Lynn Lake Gold Project Environmental Impact Statement

Federal IR Responses Round 3 Final Submission

August 9, 2022

Figure IAAC-R3-01-1 MacLellan Site Rock Quality Designation with Depth Below Top of Bedrock Relative to Groundwater Flow Model Layers

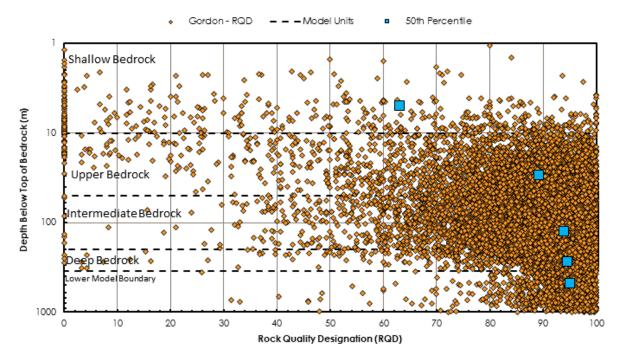
ID:	IAAC- R3-01
	Peoples, and other valued components (VCs) that may be affected by changes in groundwater and, through groundwater-surface water interactions, surface water quality and quantity.
Information Request:	 a. Provide a plot showing the site-specific relationship between RQD and hydraulic conductivity for the Gordon and MacLellan sites. b. Using the existing model, provide an updated sensitivity analysis for the MacLellan site in which recharge, intermediate bedrock hydraulic conductivity, and deep bedrock hydraulic conductivity are adjusted. Should an upper limit on recharge limit the calibration of the model, present site-specific evidence for the recharge limit. i. If needed, revise the effects assessment for all relevant VCs to account for the results of the sensitivity analysis.

Response:	 a. It is not possible to plot RQD versus hydraulic conductivity on a graph as the RQD measurements on the borehole logs that have corresponding hydraulic conductivity data are presented graphically and it is difficult to understand the length of the run and the corresponding RQD measurement to create an accurate graph. Regardless, a direct relationship between RQD and hydraulic conductivity of the given tested bedrock intervals is unlikely to be clearly defined, as it is the relationship of RQD of the overall bedrock with depth that controls the ability to transmit water which is explained herein. RQD is a measure of the degree of jointing or fracture in a rock mass, measured as a percentage of the drill core in lengths of 10 cm. For the MacLellan site, the RQD was logged across 17,238 core runs from boreholes that extended to depths of 1,173 m below top of bedrock. As presented in Figure IAAC-R3-01-1 (Attachment IAAC-R3-01), the RQD of the shallow 10 m of bedrock is generally more variable than the RQD measured greater than 10 m. For example, the range of RQD (as measured by the 50th percentile) is 63% for the shallow bedrock (0 to 10 m below the top of bedrock surface), 89% for the upper bedrock (10 m to 50 m below the top of bedrock), and greater than 90% for the intermediate and deep bedrock (greater than 50 m below the top of bedrock). A clear decreasing trend in RQD with depth is observed in the borehole data at the MacLellan site. Over 85 hydraulic conductivity tests were completed within boreholes that extended to depths up to 256 m below the top of bedrock at the MacLellan site. Over 85 hydraulic conductivity of bedrock with depth below top of bedrock is presented in Figure IAAC-R3-01-2. As shown in Figure IAAC-R3-01-2 (Attachment IAAC-R3-01). the hydraulic conductivity of bedrock the hydraulic conductivity ranges over two orders of magnitude from 1x10-⁸ to 1x10-⁷ m/s. The decreasing trend in RQD with depth provides an indication of the degree of jointin

ID:	IAAC- R3-01
	hydraulic conductivity of the tested interval was on the lower end of the estimated values at 1x10 ⁻⁸ m/s. A low RQD with low hydraulic conductivity at these depths indicate that despite the presence of fractures, the fractures are not well connected within bedrock which limits the overall flux through the bedrock and resulting in a lower estimated value of hydraulic conductivity for that tested interval.
	There is no available hydraulic test data for the bedrock interval from 256 m to 350 m, which represents the lower portion of the groundwater flow model. However, there are 551 measurements of RQD across this bedrock interval and the geological formation is consistent with the hydraulically characterized bedrock interval of the intermediate and deep model layers. Given that the bedrock from 256 m to the base of the model domain at 350 m is the same geological formation and has the same overall trend of decreasing RQD with depth as the hydraulically tested intervals of deep and intermediate bedrock, it is reasonable to assume similar hydraulic properties.
